In the public hearing I presented issues with traffic associated with the proposed project at 7113 Burnet.

In this piece I want to look closely at the utility of the shared access negotiated for using the parking lot of the shopping center just north. It is proposed, because direct Burnet Rd access is blocked by the left turn lane of the Greenlawn traffic signal. The parking lot has the traffic signal at Greenlawn and Burnet to access Burnet Rd travel.

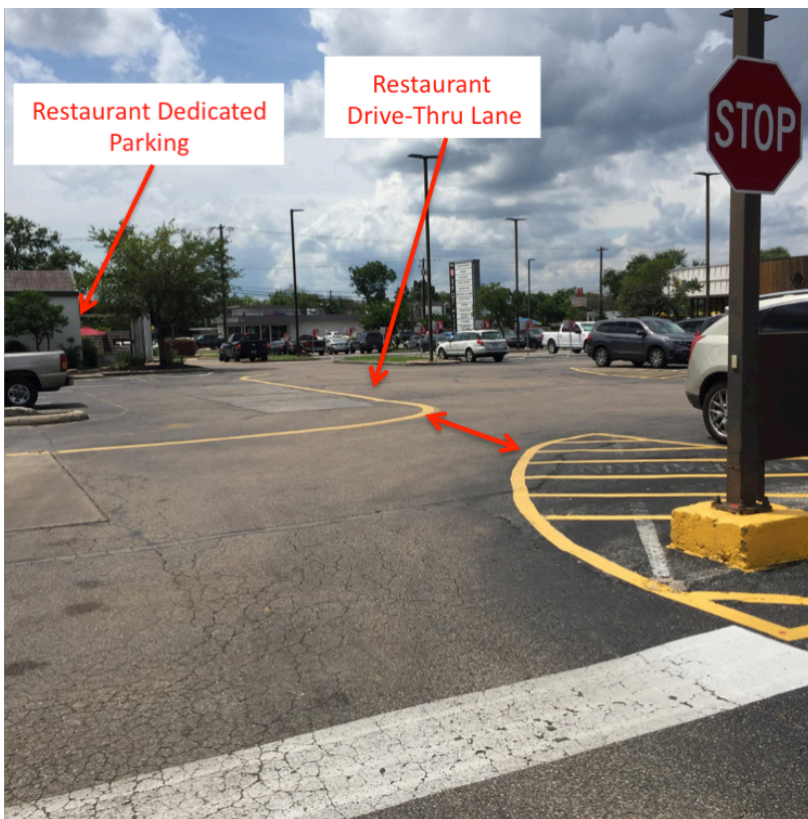
First notice the difference in elevation of the two parking lots.

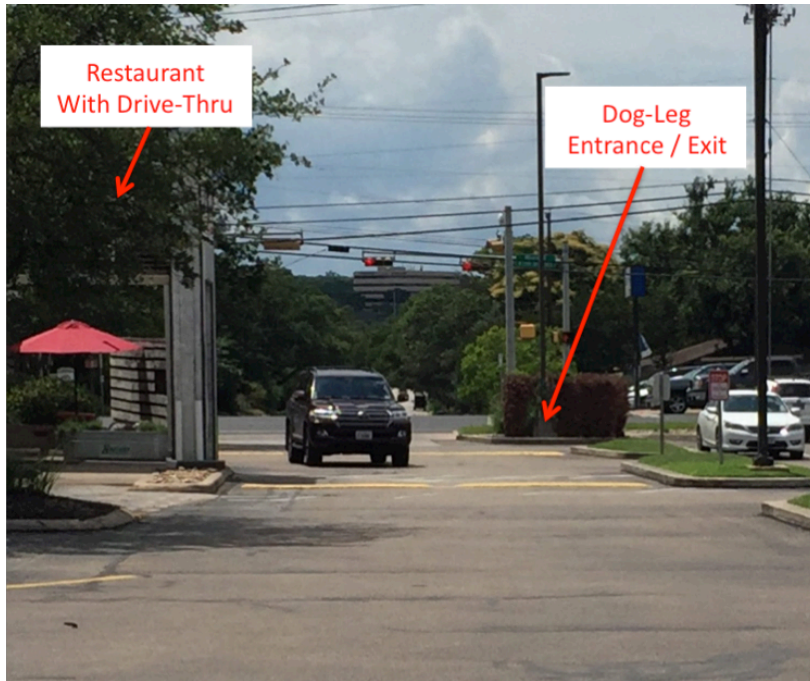
And, that the ramp slopes at about 12% to 16% grade to match the elevations. And, the ramp is constrained on the top side by buildings and customer parking. This forces ramp use to start and end with a turn. For trucks, this is an 'S' turn: cab turns in, cab goes to exit while truck tail is still hasn't entered, cab must start turn to avoid parking and building, truck tail enters ramp and immediately begins turn to exit.

As seen here, the route through the parking lot is narrow.

The route is only wide enough for a single car at a time. And, the restaurant traffic turn radius prevents widening the route.
